Submission to Utilities Commission

PWC Networks Pricing proposal: 2014 Regulatory Reset

UC Draft Decision and PWC Revised Proposal

March 2014

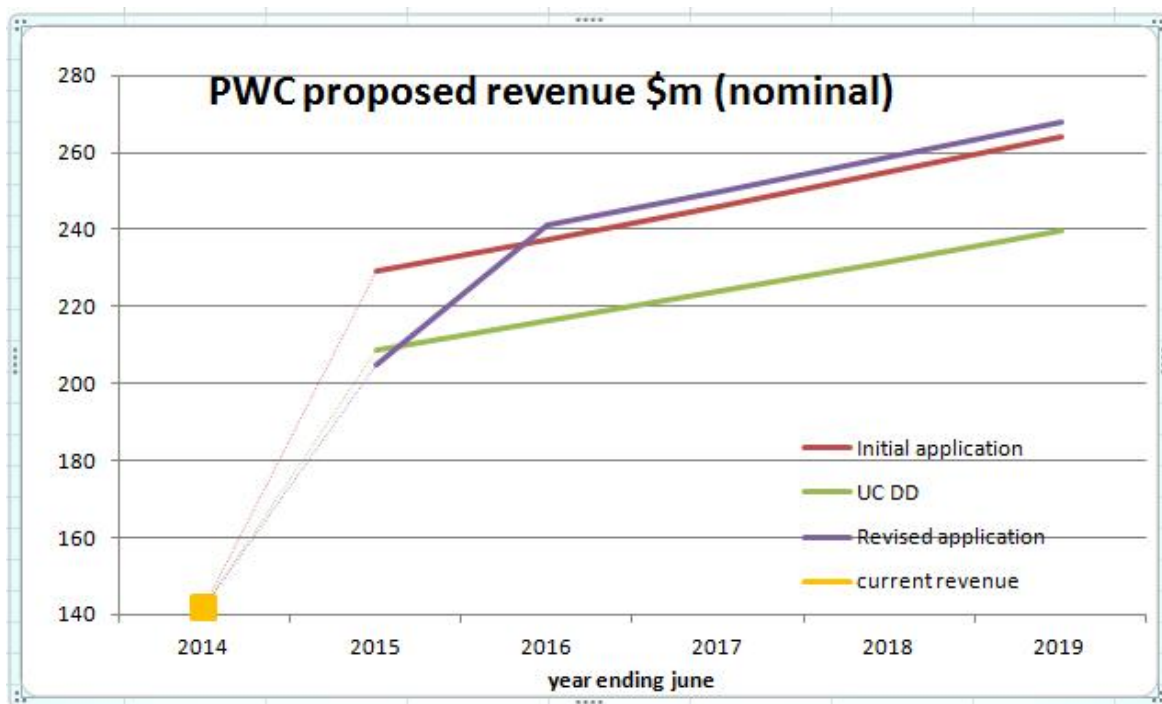
The revenue sought by PWC in its initial and revised applications and the UC draft decision impose a massive revenue shock on consumers as the following chart shows.

With a modest (if any) increase in demand or consumption, the entire step increase will apply to PWC prices converting the revenue shock into a price shock of similar magnitude.

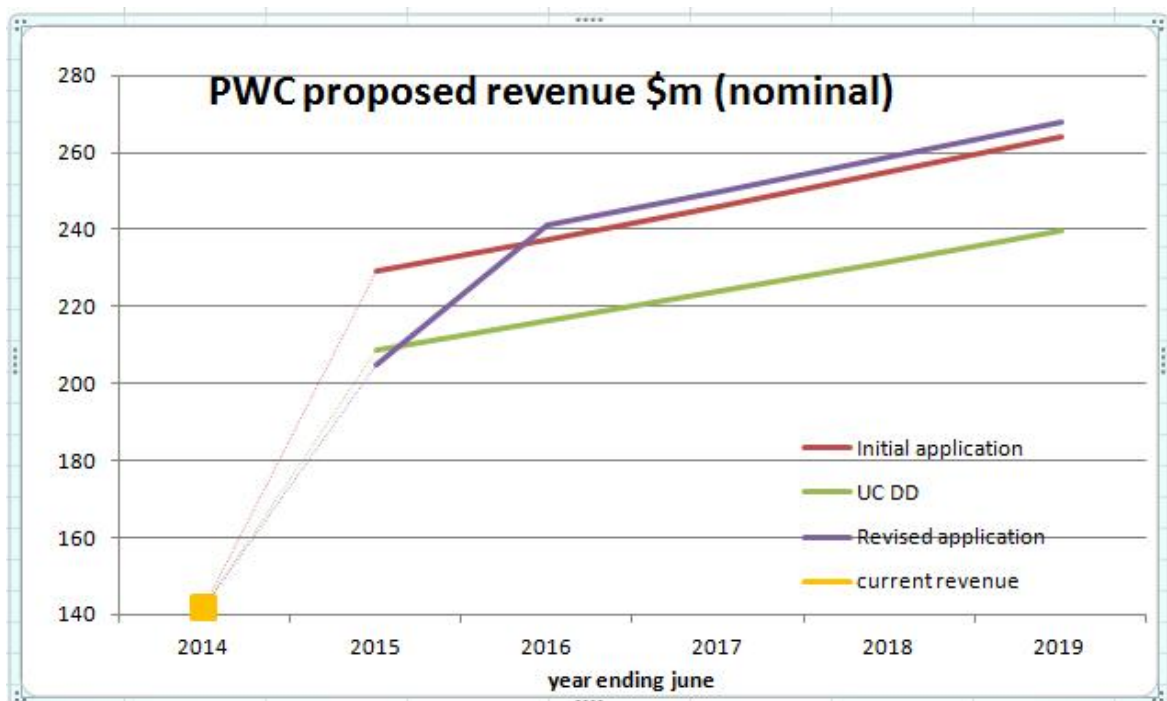
The flowing chart shows the additional revenue the PWC is seeking and what the UC draft decision will impose on consumers compared to what the current revenue allowance is.

Overall, both the revised application and the UC draft decision impose a nearly 50% increase in the PWC Network revenue. This massive increase in revenue is despite the UC consultant's (PB Strategic Consulting) assessment that PWC is not efficient and it is the NTMEU view that PWC has operated inefficiently in the past and seeks to continue to do so by essentially seeking to operate on a cost plus basis for the next regulatory period.

Figure 4-1: Capital expenditure 2009-10 to 2018-19 (\$M, 2013-14)

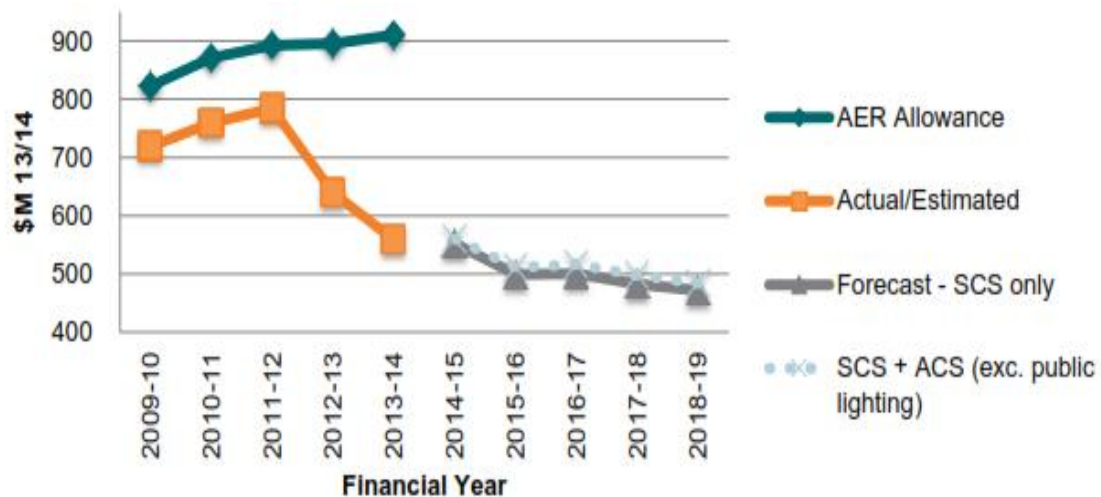
basis of expected growth. In practice its capex program shows considerable under-run on the allowance as a result of growth being considerably less than forecast. The actual capex is shown in the following chart

The bulk of the capex not used related to augmentation projects not required because of lower than predicted demand and, as a result, Essential garnered a massive benefit approaching \$200m over AA3 in not using its capex allowance that it had argued earlier was essential due to growth. What is also important was the observation that although augmentation capex was considerably less than allowed by the regulator, Essential overspent on replacement capex.

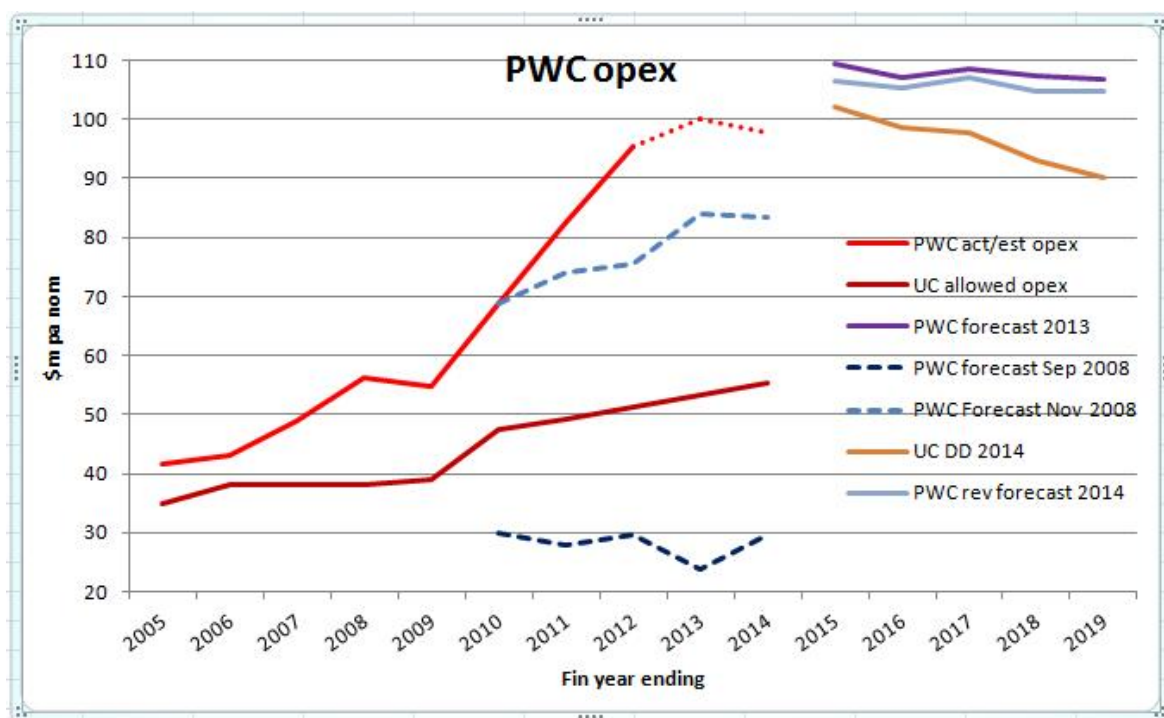
A similar observation can be made regarding compliance capex which has seen a doubling of cost between AA3 and AA4

The NTMEU considers that the reduction in capex included by the UC in its draft decision is to be welcomed, but still appears to be inflated for replacement capex and probably compliance capex.
